4. South East Vale Sub-Area

East of Sutton Courtenay (8.83 ha)

MM42

East of Harwell Campus (Harwell and Chilton Parishes) (61.74 ha)

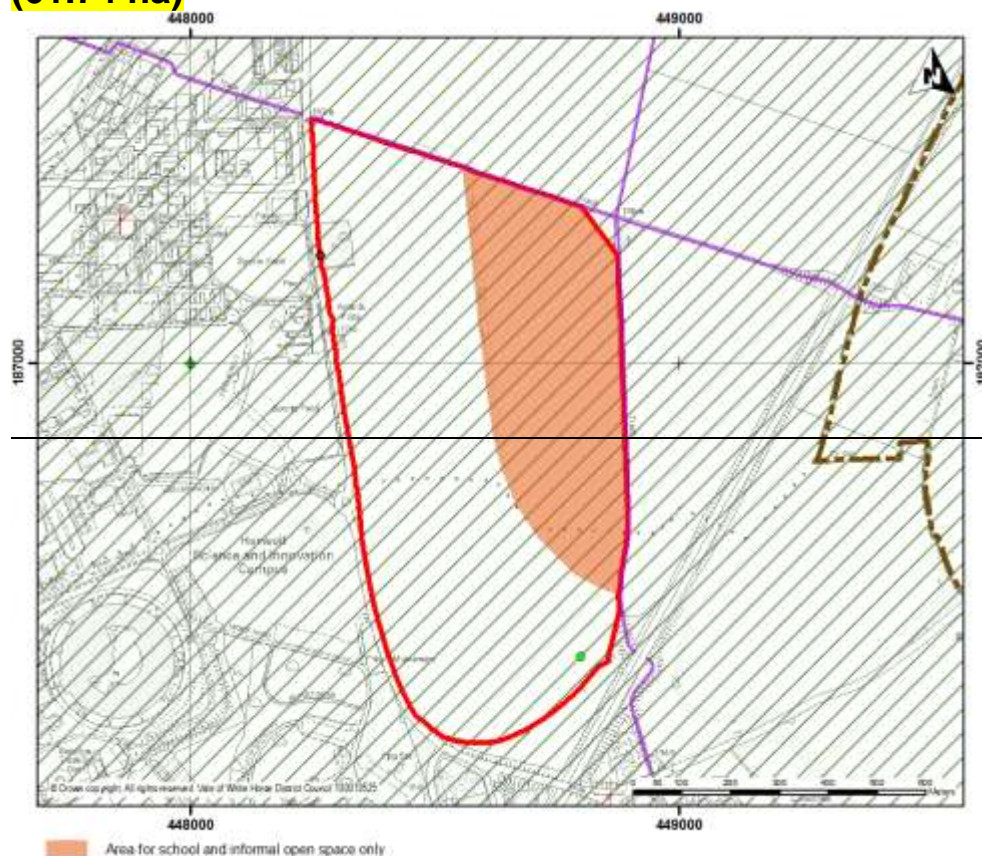
MM54

North of Harwell Campus (18.93 ha)

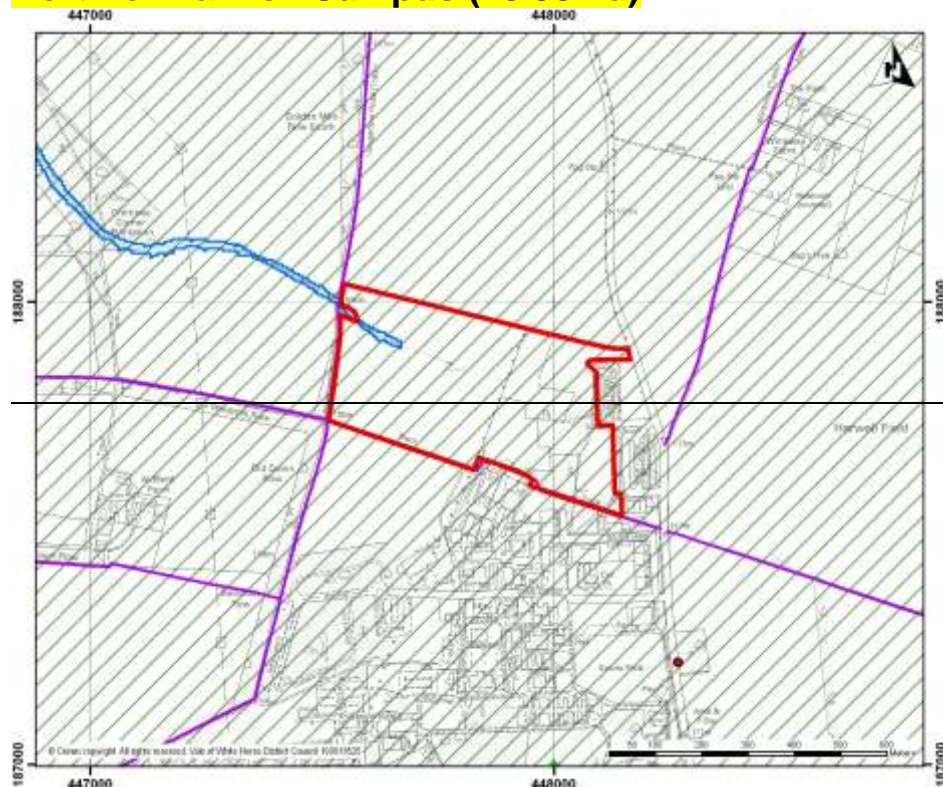
MM55

Monks Farm, Grove (56.7 60.63 ha)

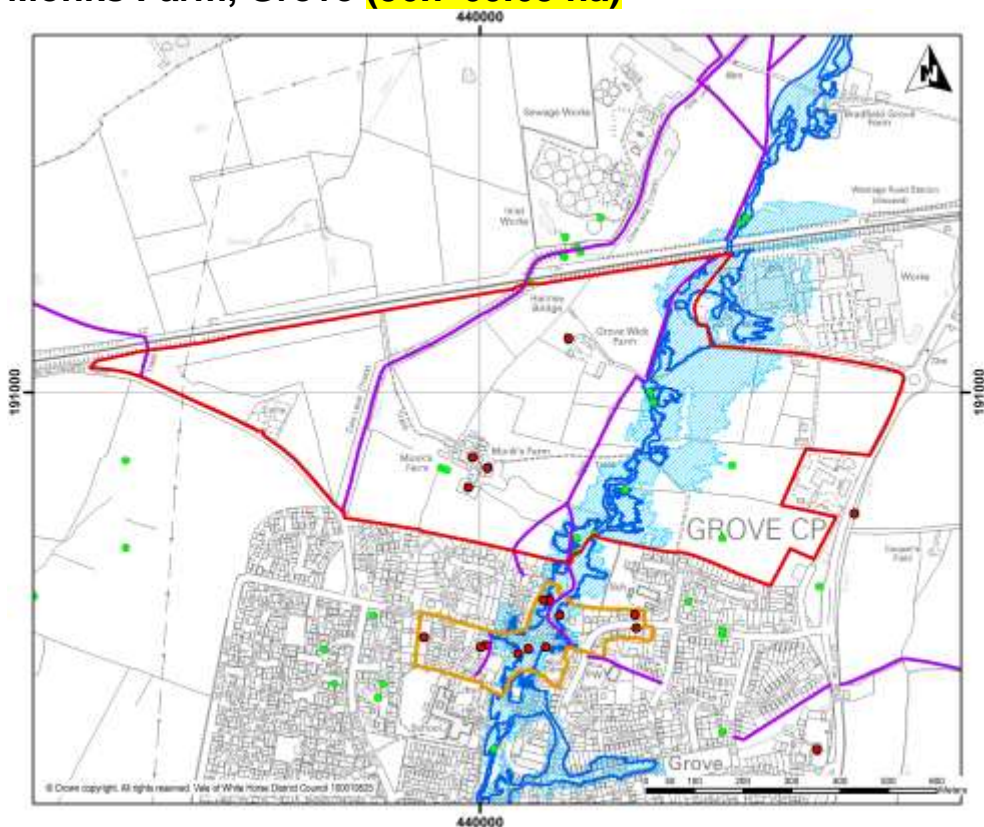
MM56

Use: Around **750-885** homes and circa 6 ha of employment land, subject to masterplanning.
